EXHIBIT D
1995 CONSTRUCTION PERMIT

Re: 327 IAC Article 3 Construction
Permit Application
Plans and Specifications for
New London Conservancy District
Sewers and WWTP
Permit Approval No. 8088
New London, Indiana

Re: Application for Construction Permit
Wastewater Facility Project
New London Conservancy District
Response to Review Comments

PUMPING SYSTEM CURVE - FLOW VS. HEAD New London Combined 2.0 & 3 inch

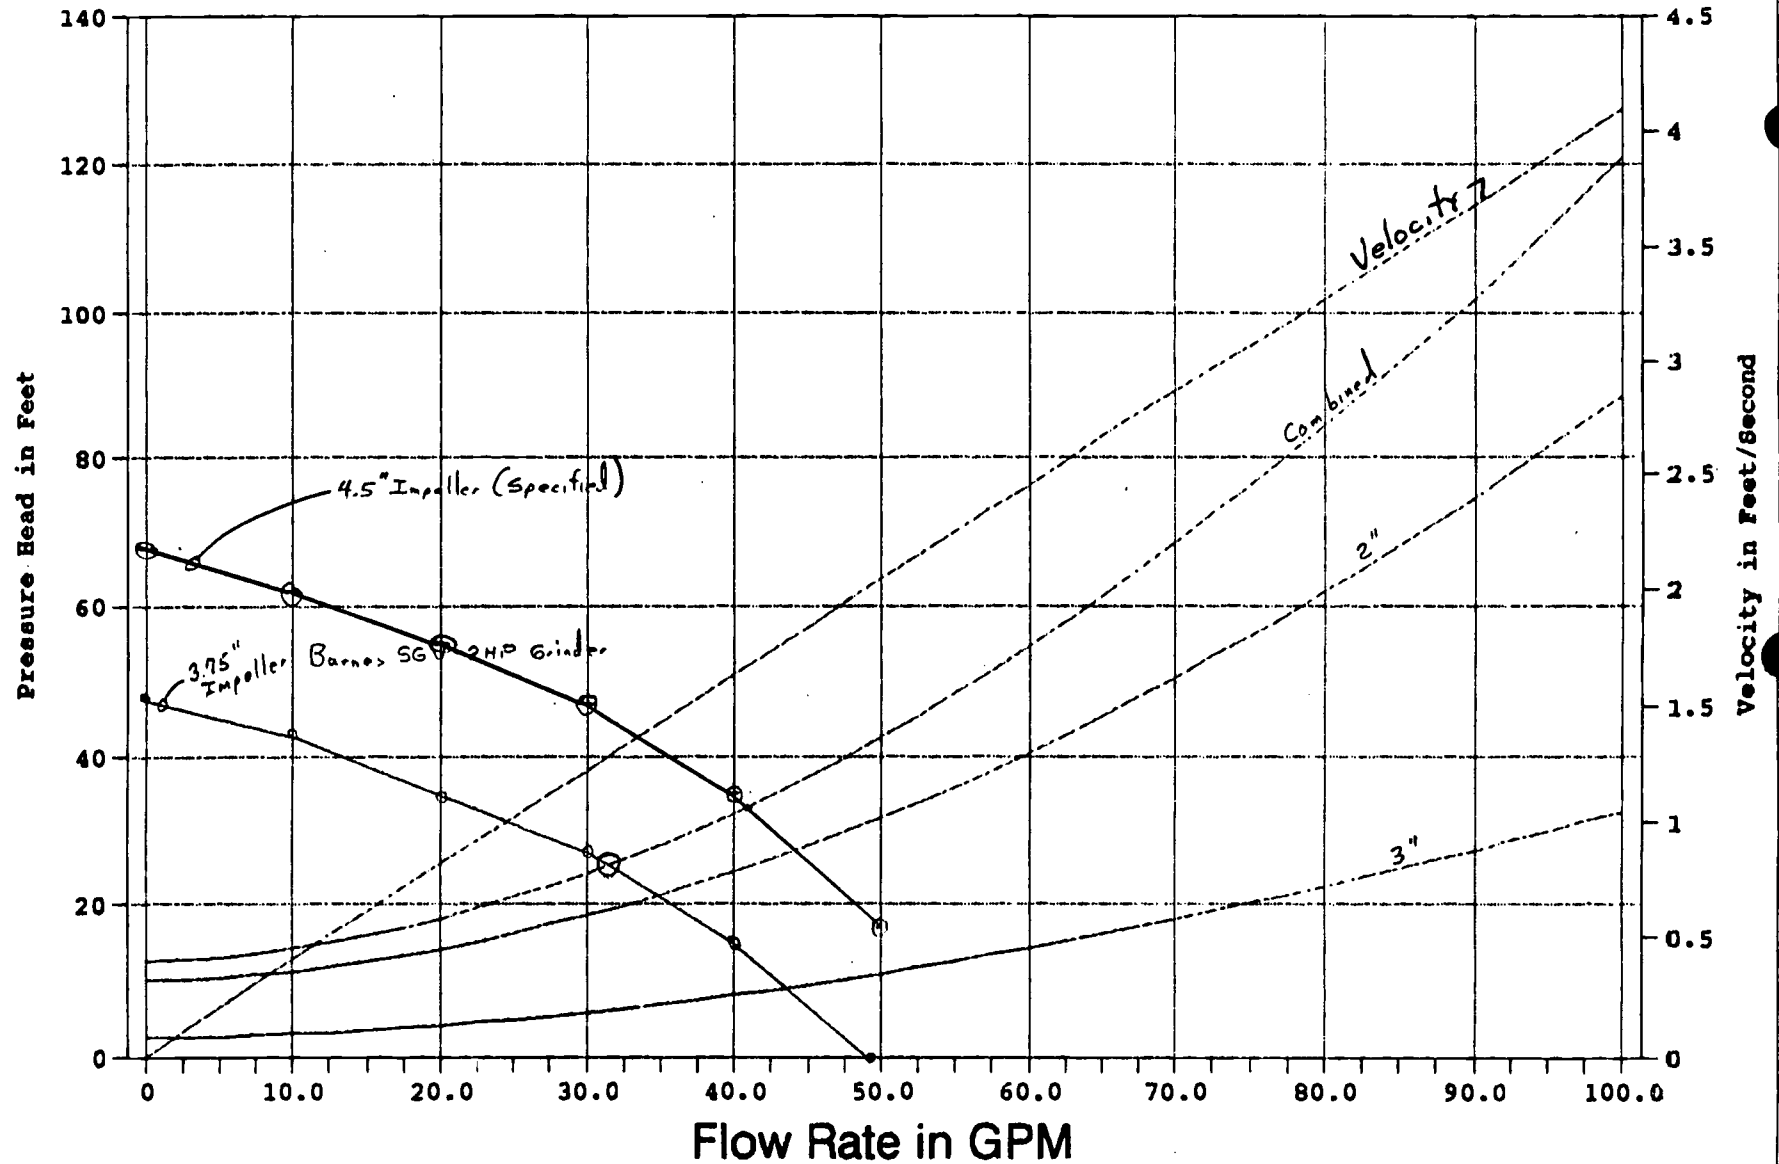
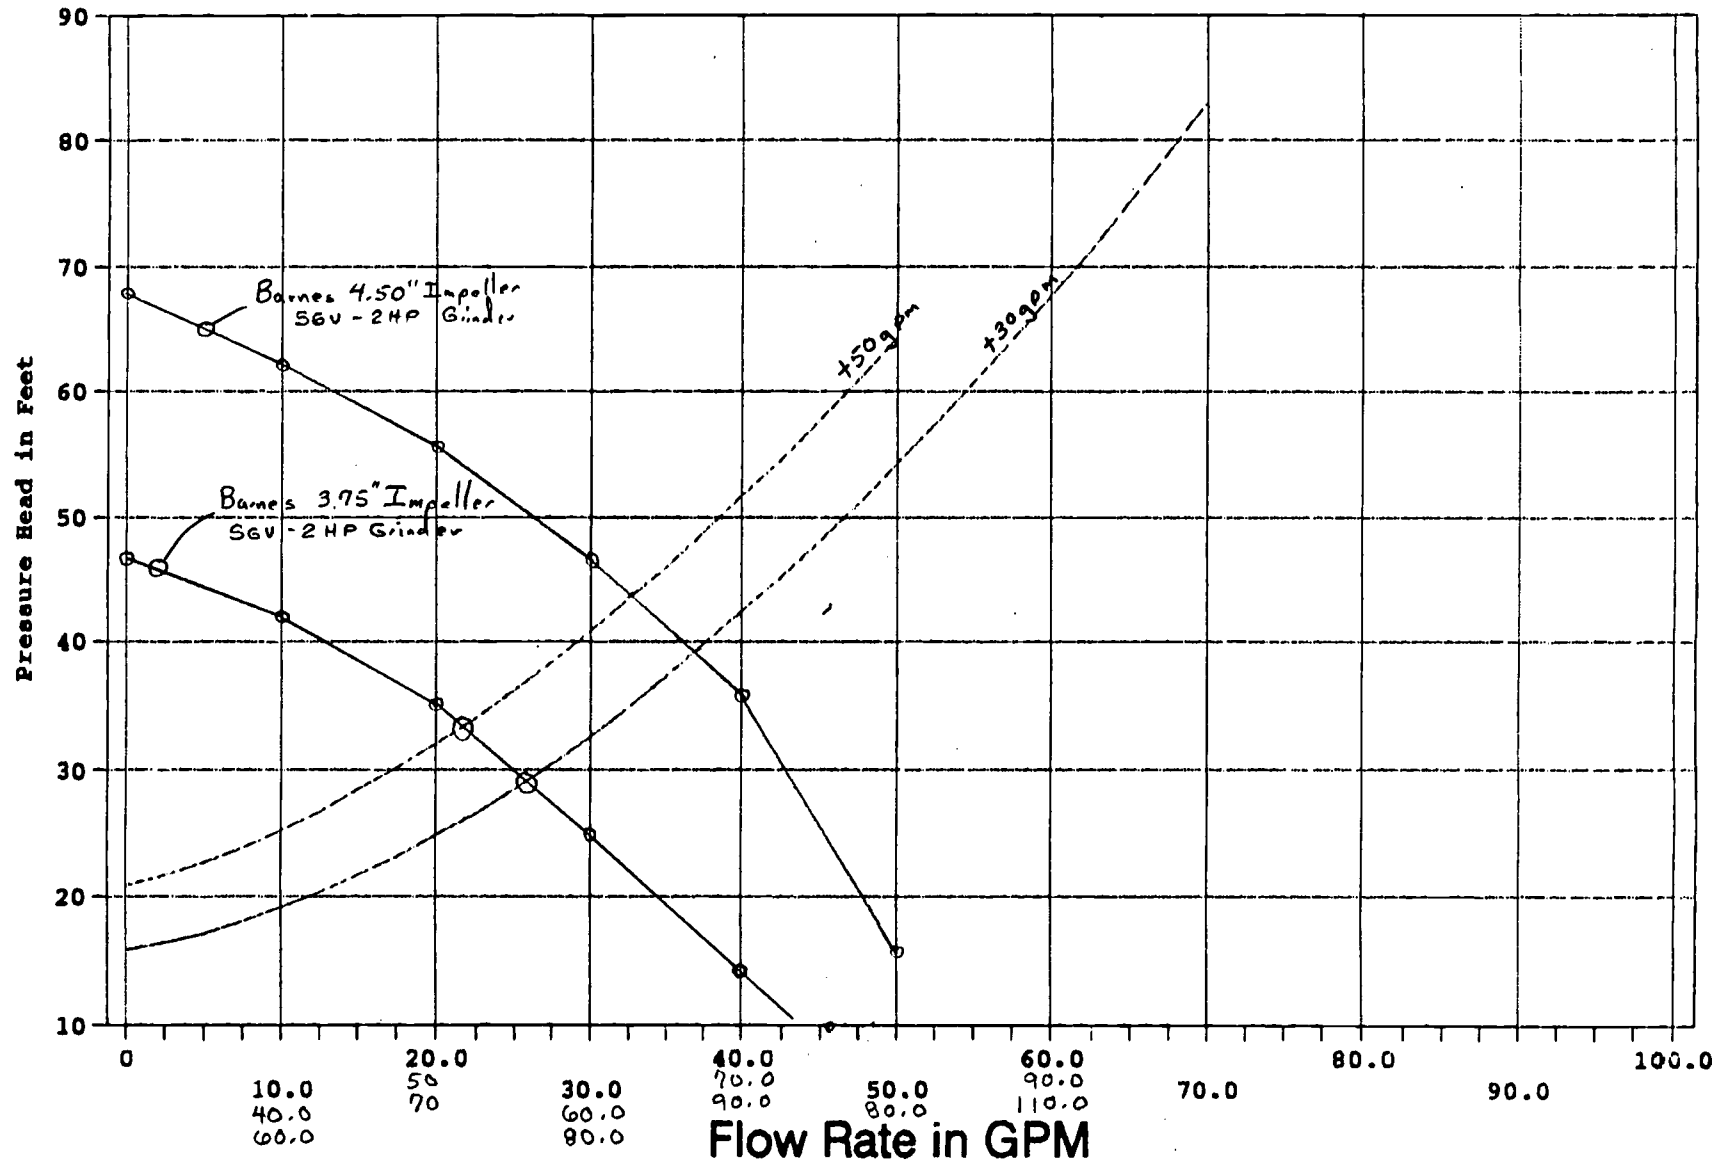
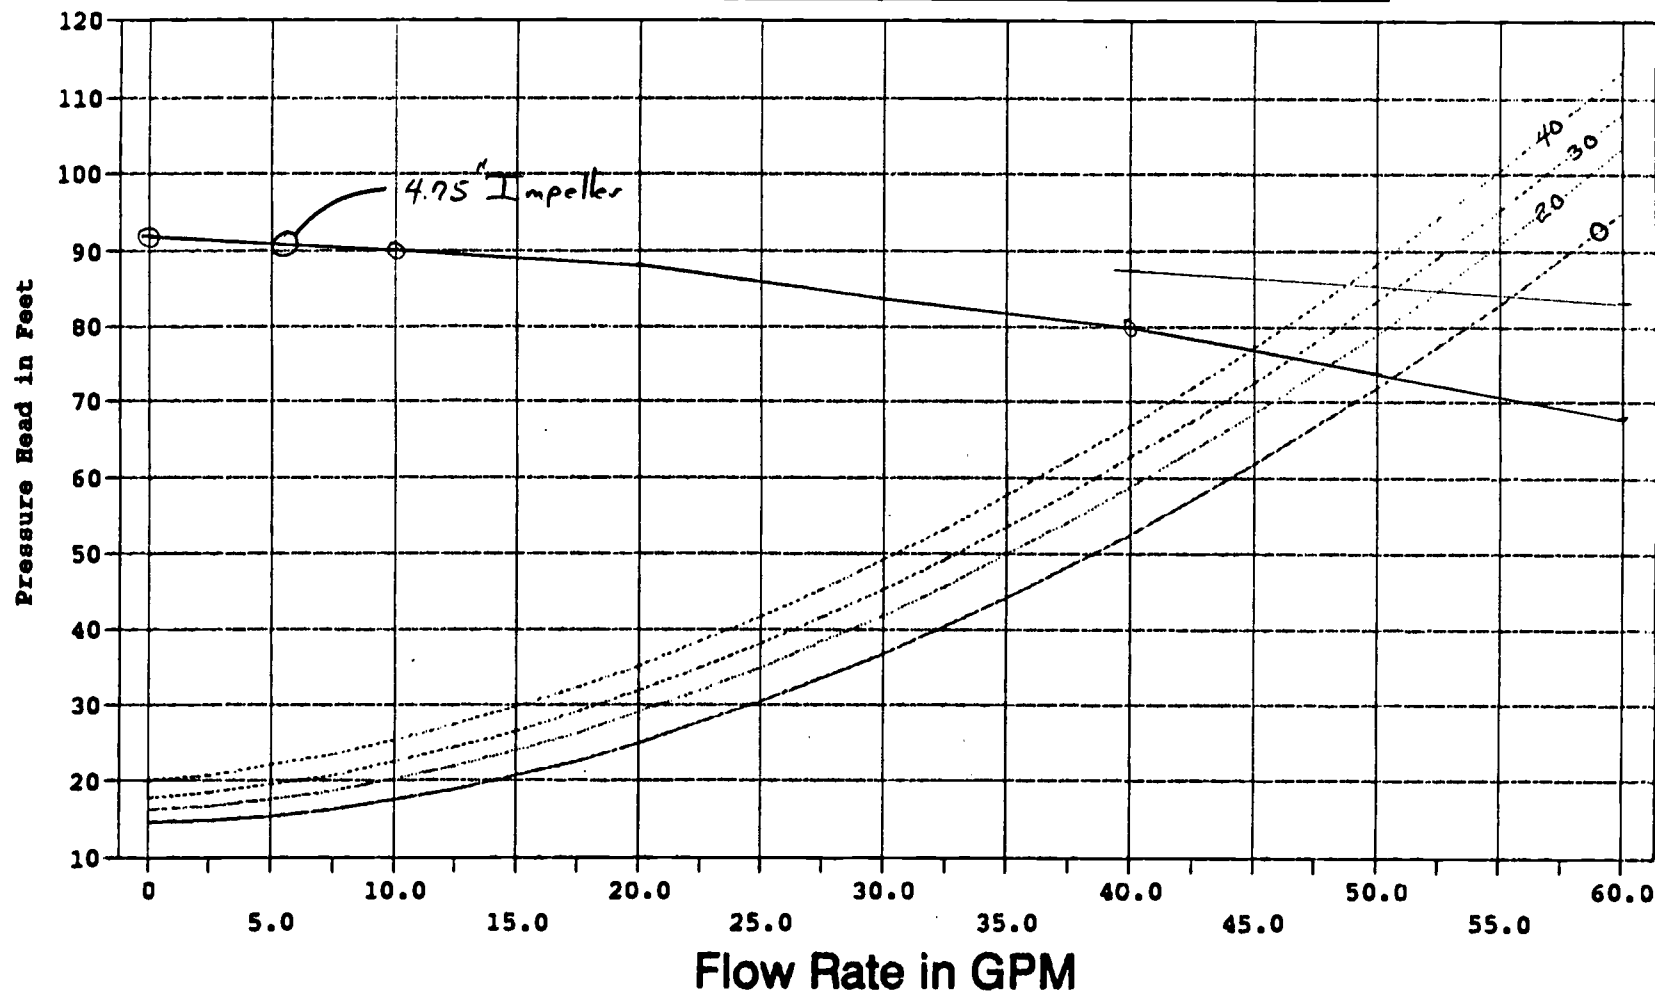
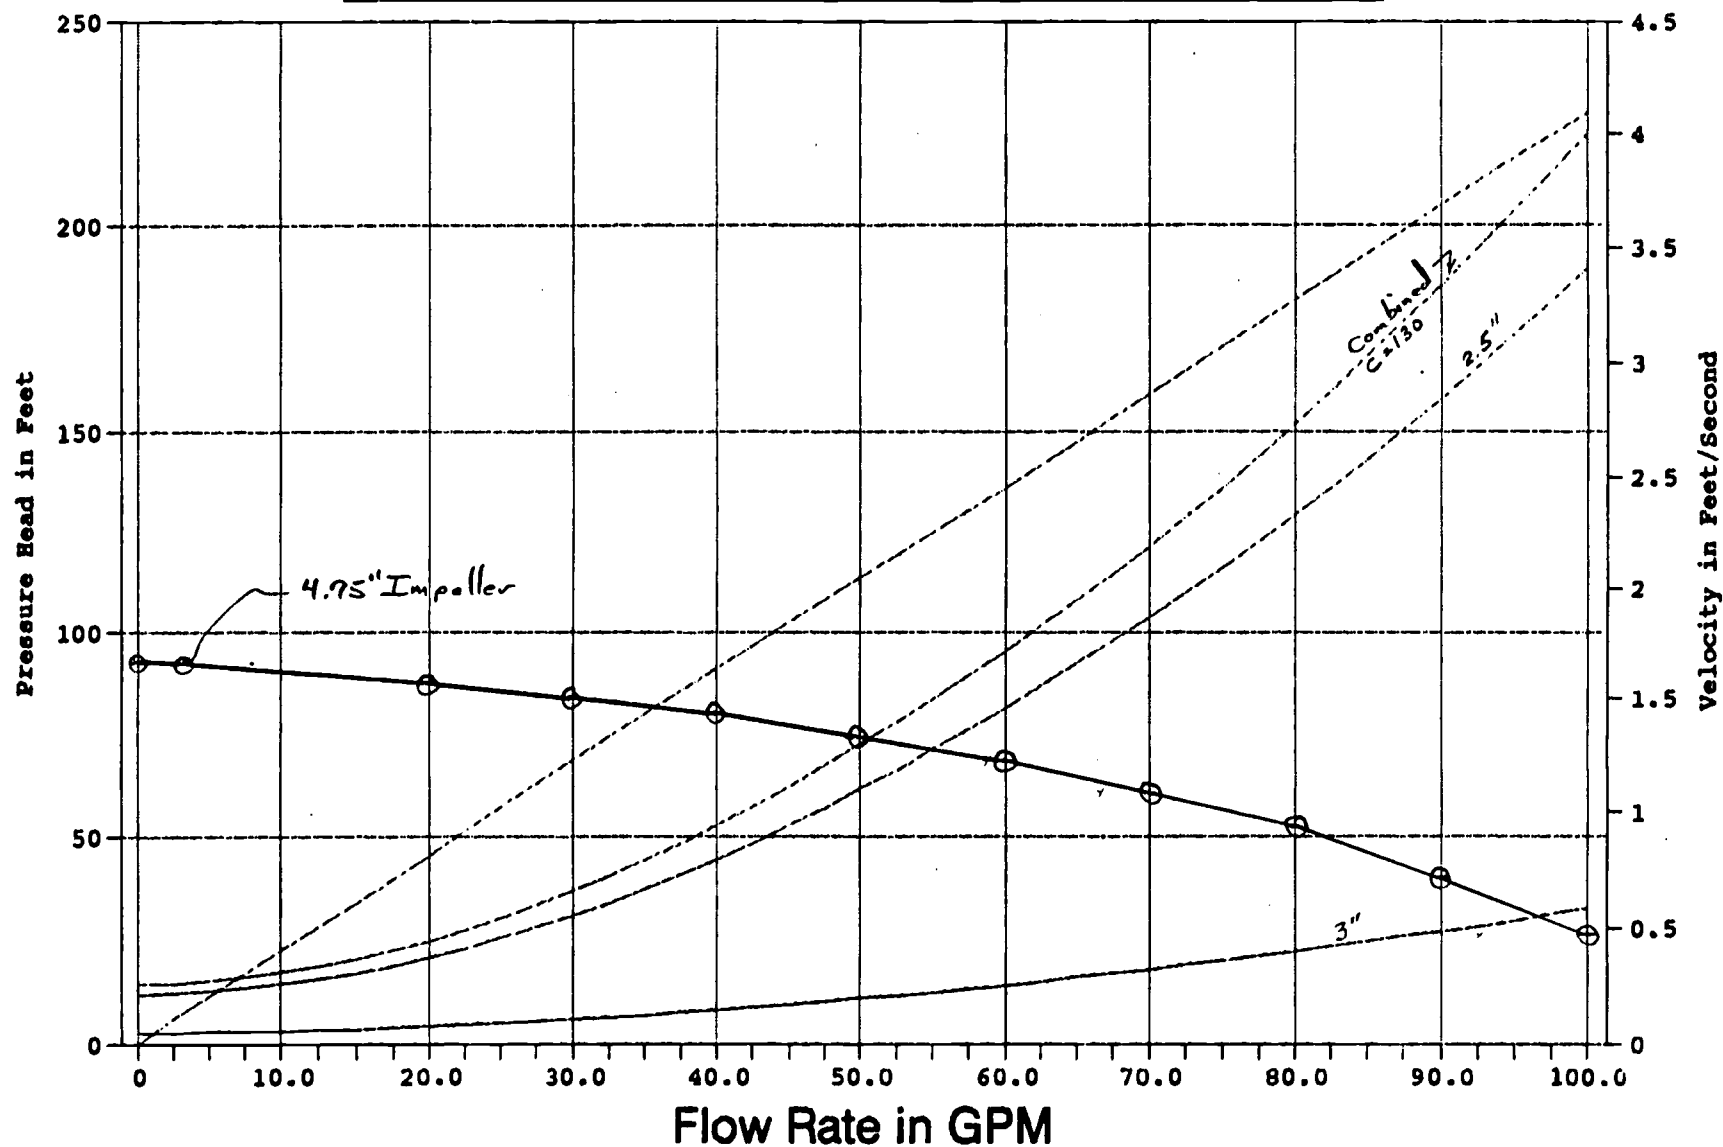
- **Comment No. 2** - The force main system curves and pump curves should be submitted and included with the design summary.

The system curves for each pump station are attached. Each pumping station has a system curve with operation by itself and no flow from the other station. Also, each pump station has a system curve showing the system with flow being produced by the other station. The system curves have the specified pump curves added to the system curves to show theoretical operating points. It is clear that each station will be capable of pumping the required peak rate when the second station is also running. We do not see a problem with the common force main design as proposed.

Engineer's Response to Comment No. 2 - The pump station system curves and pump curves are included with this transmittal. The south pumping station has been re-designed since the original submittal and is now a submersible grinder pumping station very similar to the north pumping station. The system curves are for the redesigned stations. The system curves also are combined curves which break the system into the 2", 2½", and 3" systems. A schematic of the system layout is included to assist in the understanding of the curves.
